4MC-017
with field notes

CONSTRUCTION PLANS FOR SANITARY SEWER LATERAL IN WOODLAND LAKES ESTATES SECOND ADDITION

AN ADDITION TO SEDGWICK COUNTY, KANSAS

PLAN LATERAL 89-20 (cont.)

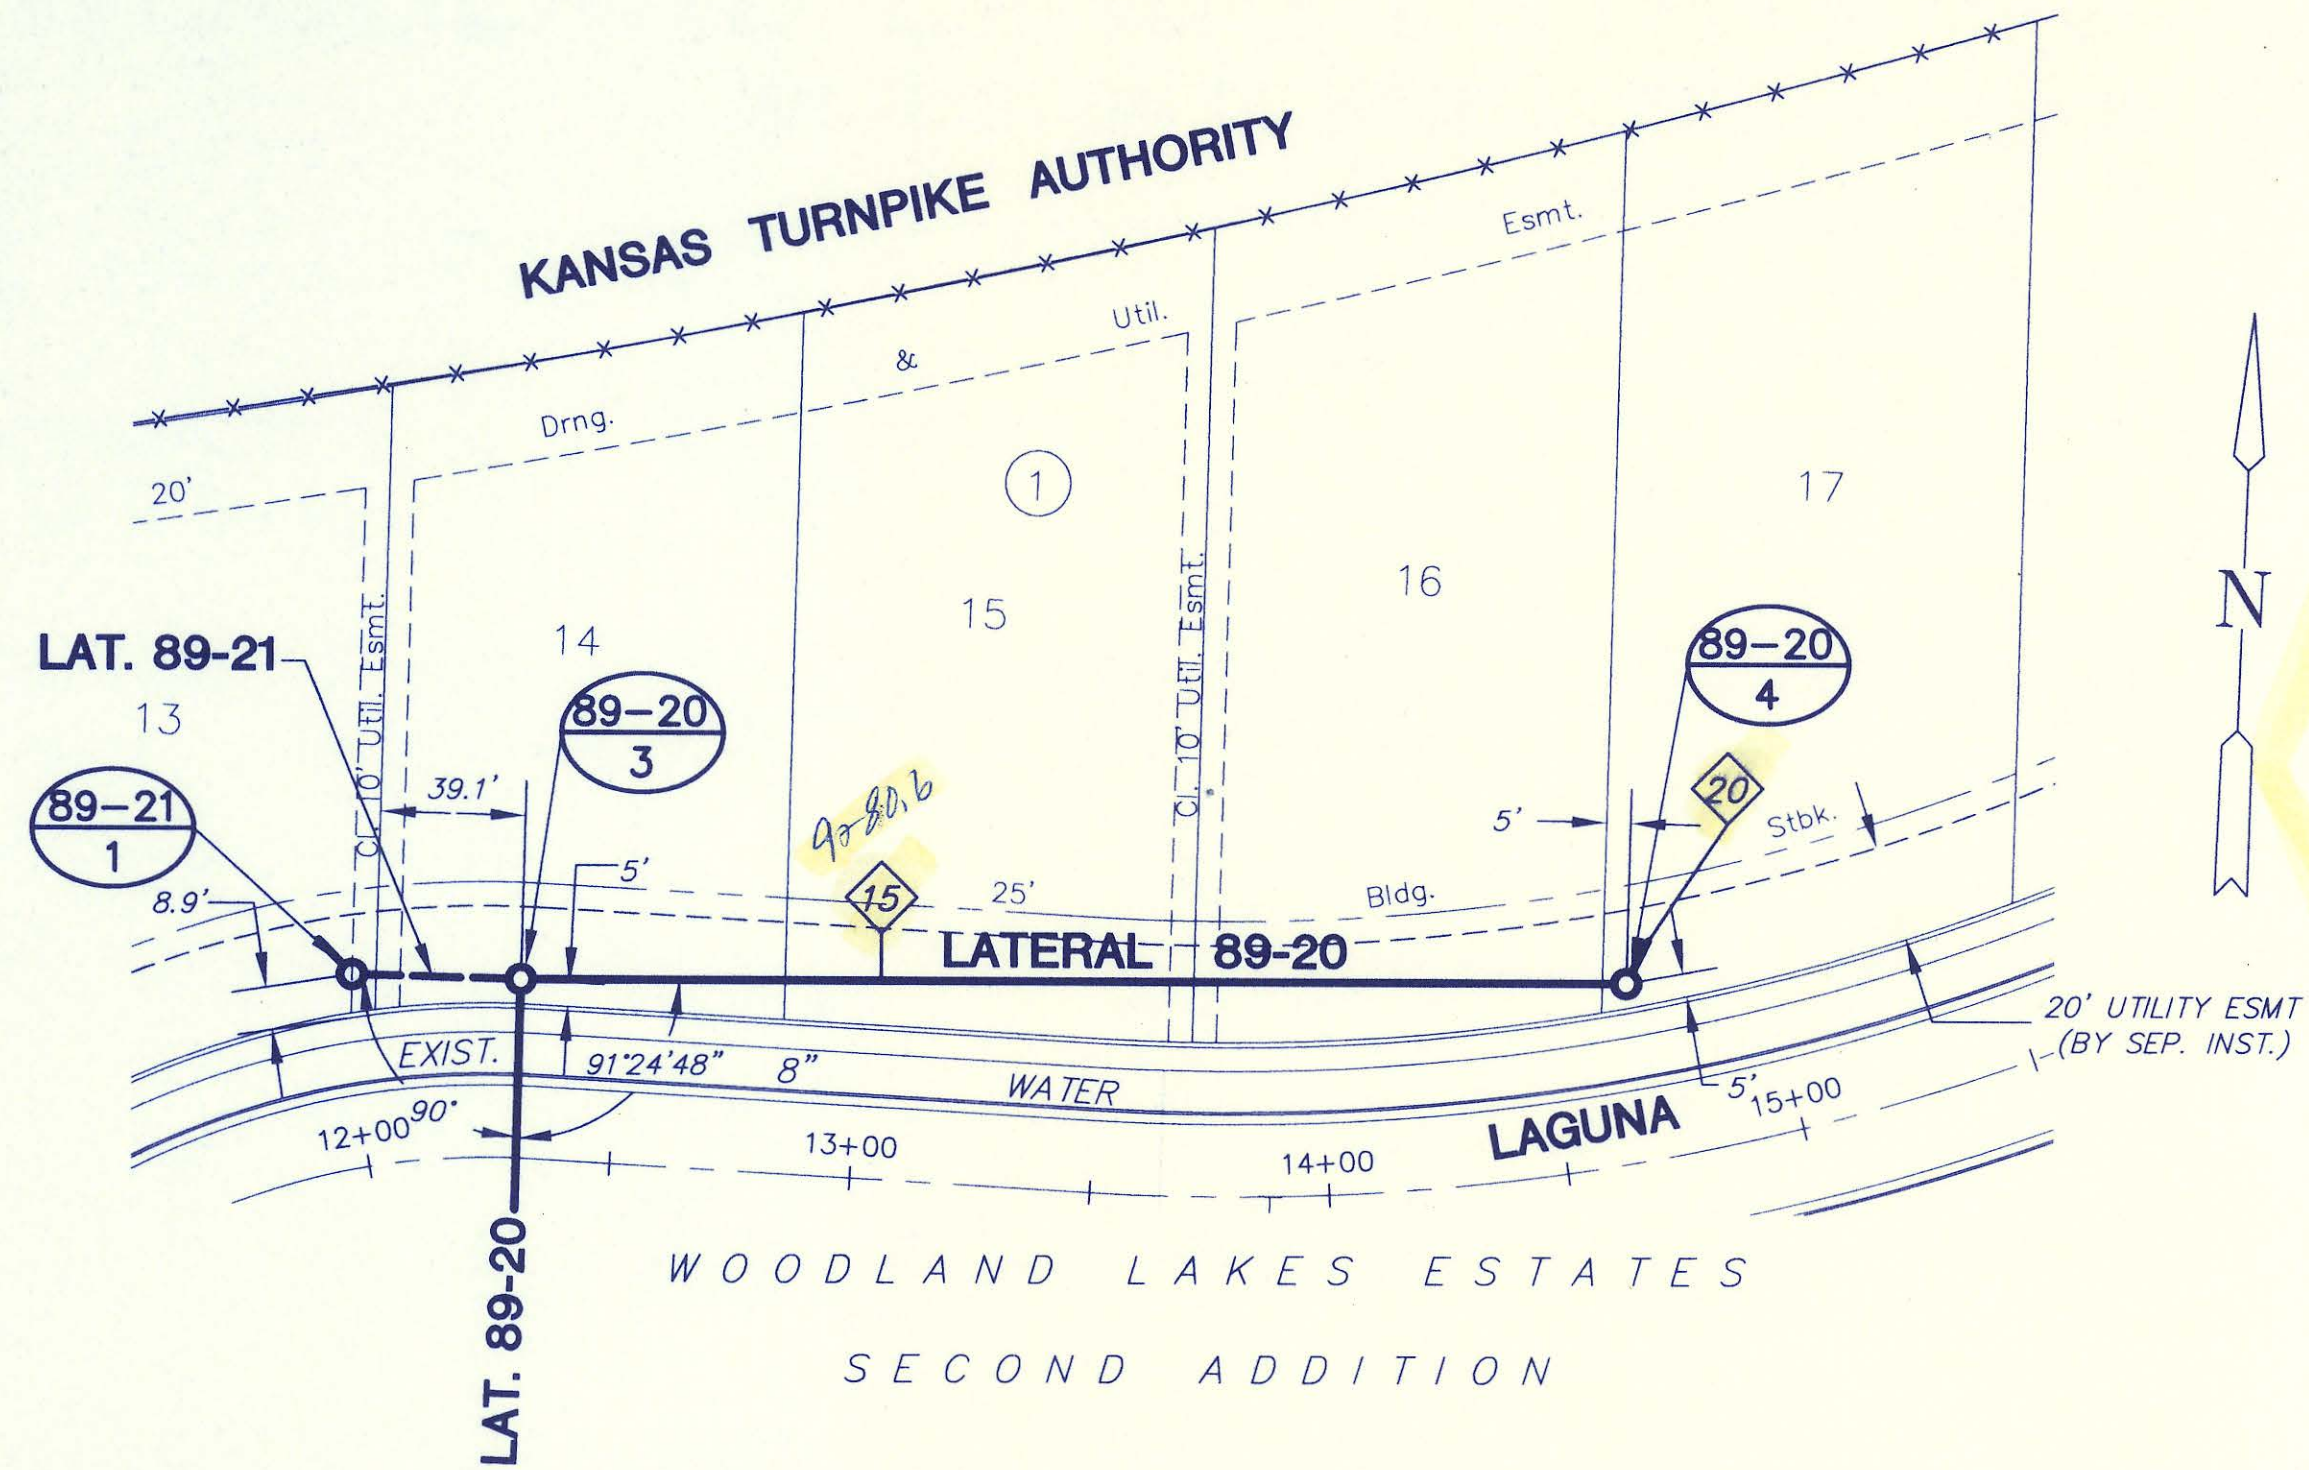
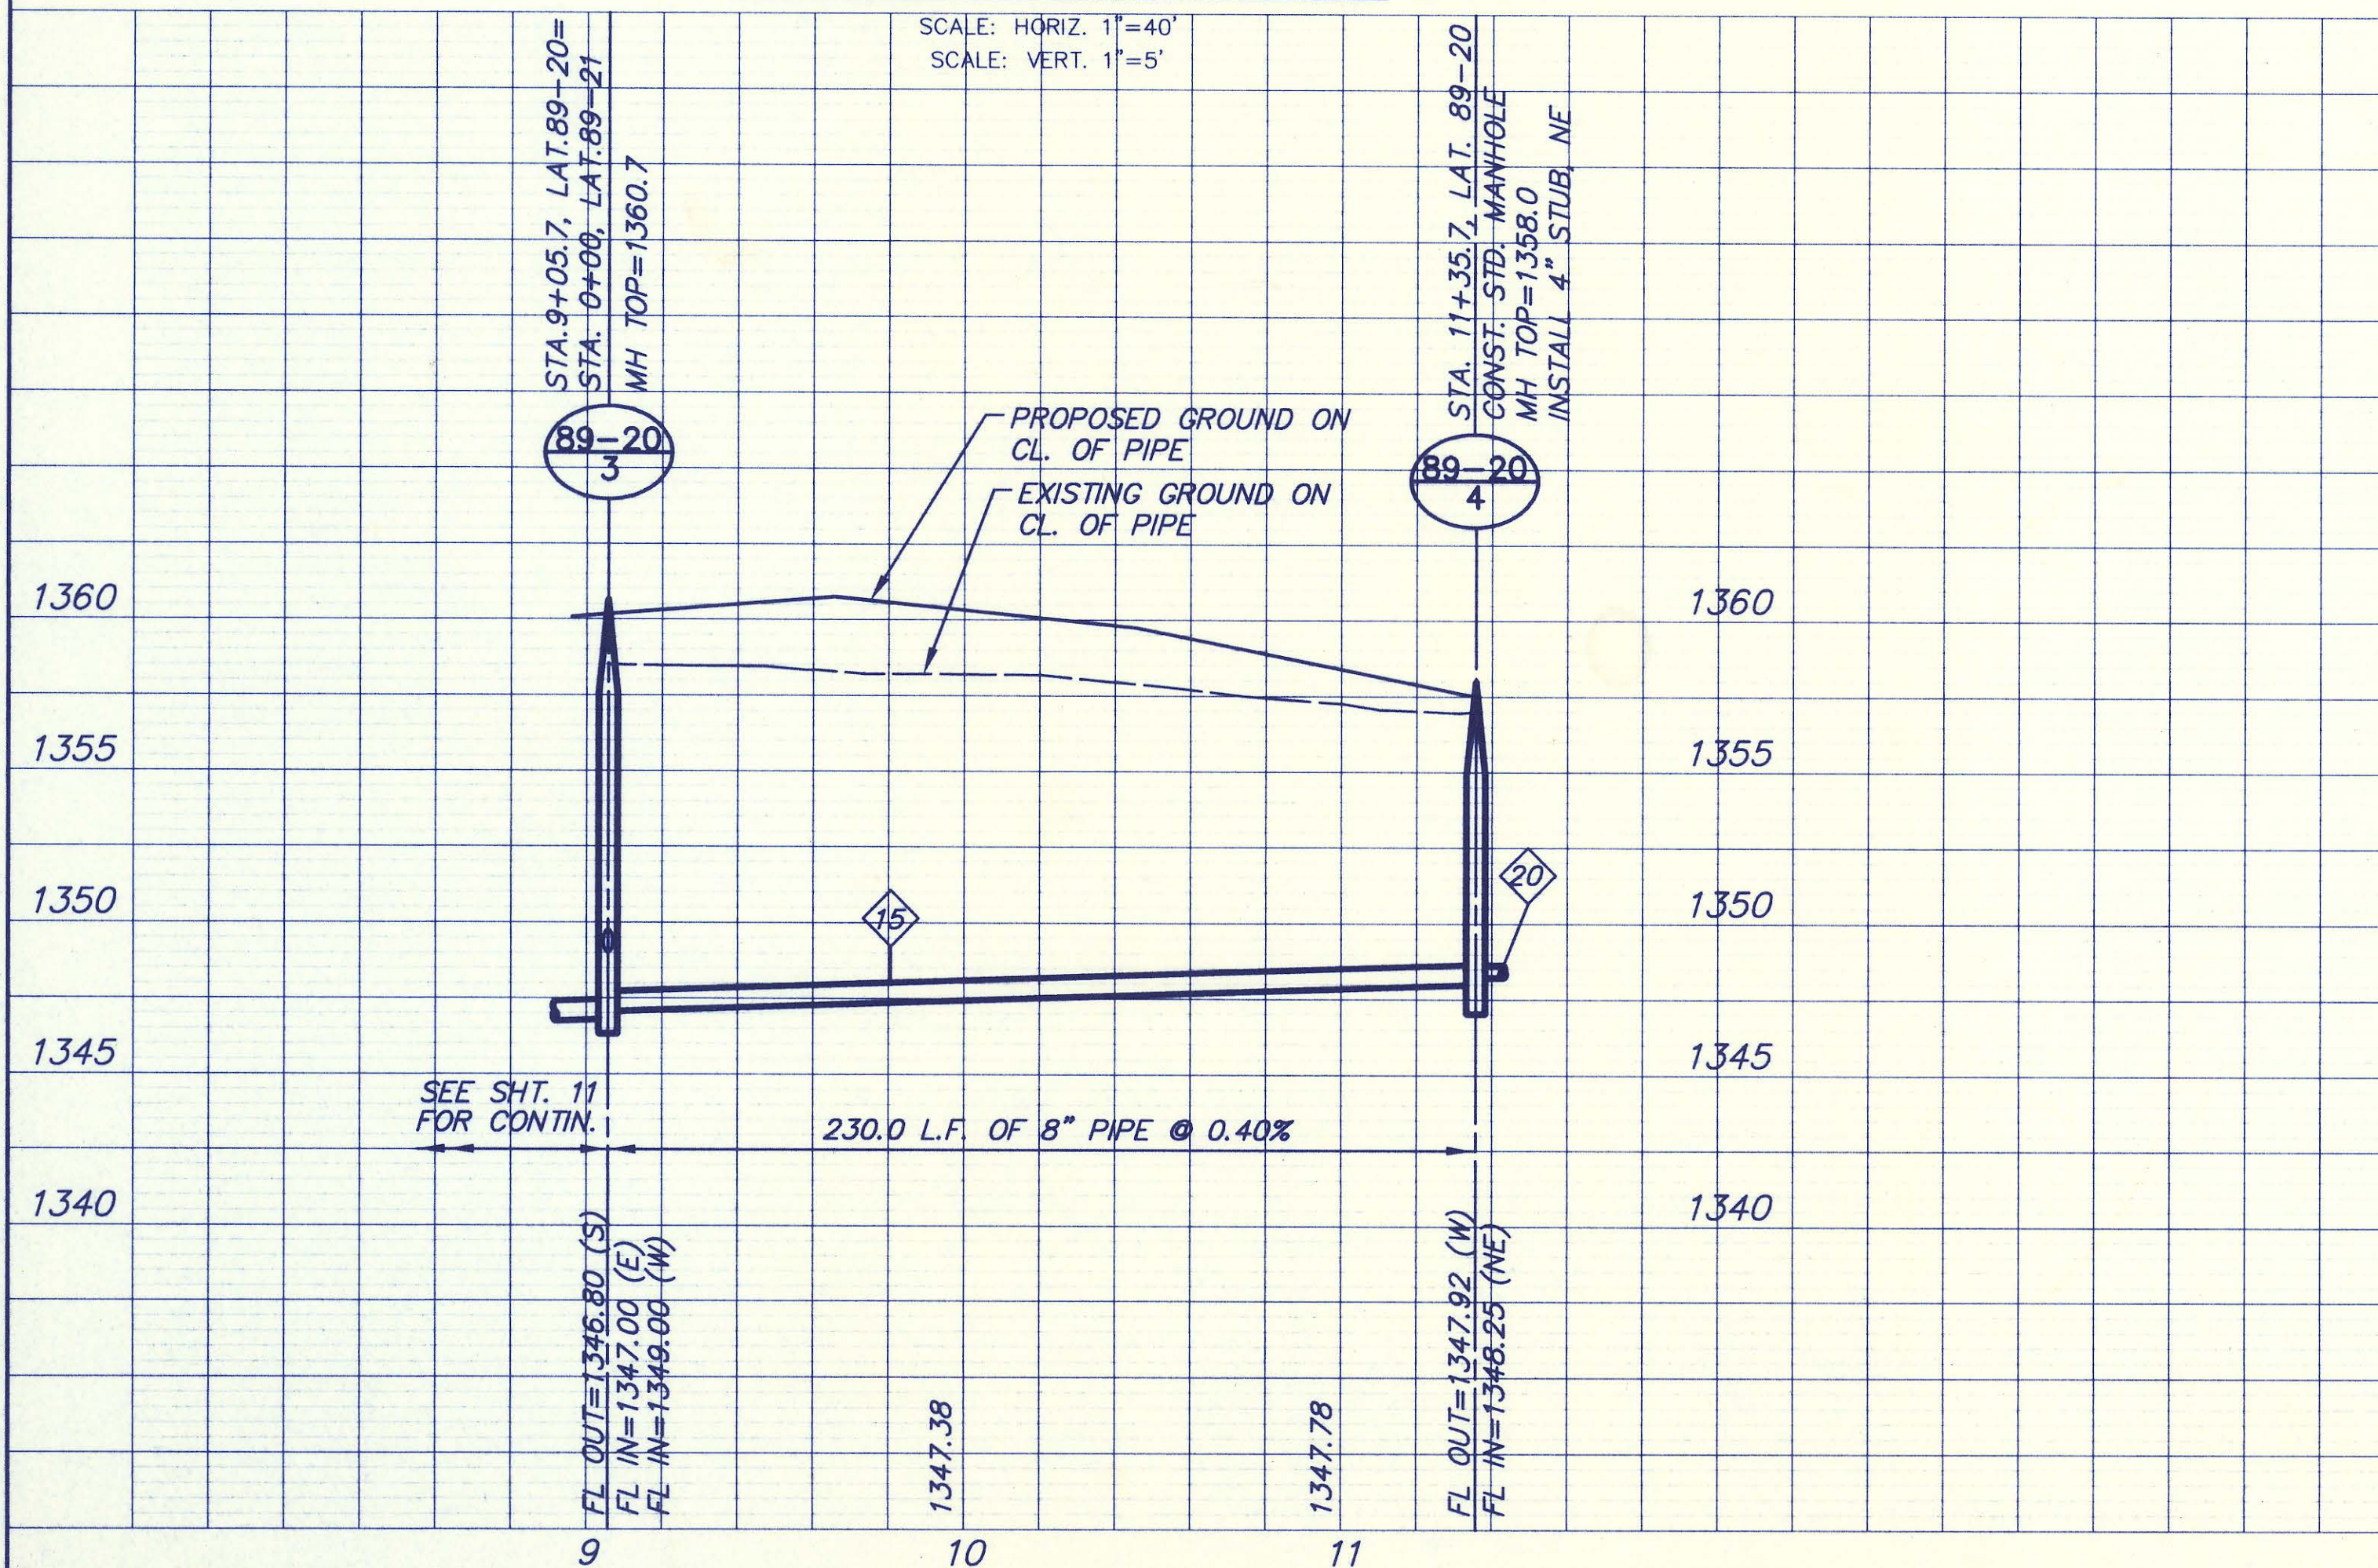
*Coreing not performed as
MH had A-Lok gasket precast
in the MH w/stub. Utilized
A-Lok, but due to deflection
of line & 10' gasket failed to
pass the test. Installed as
a waterstop w/greasing +
encasement.*
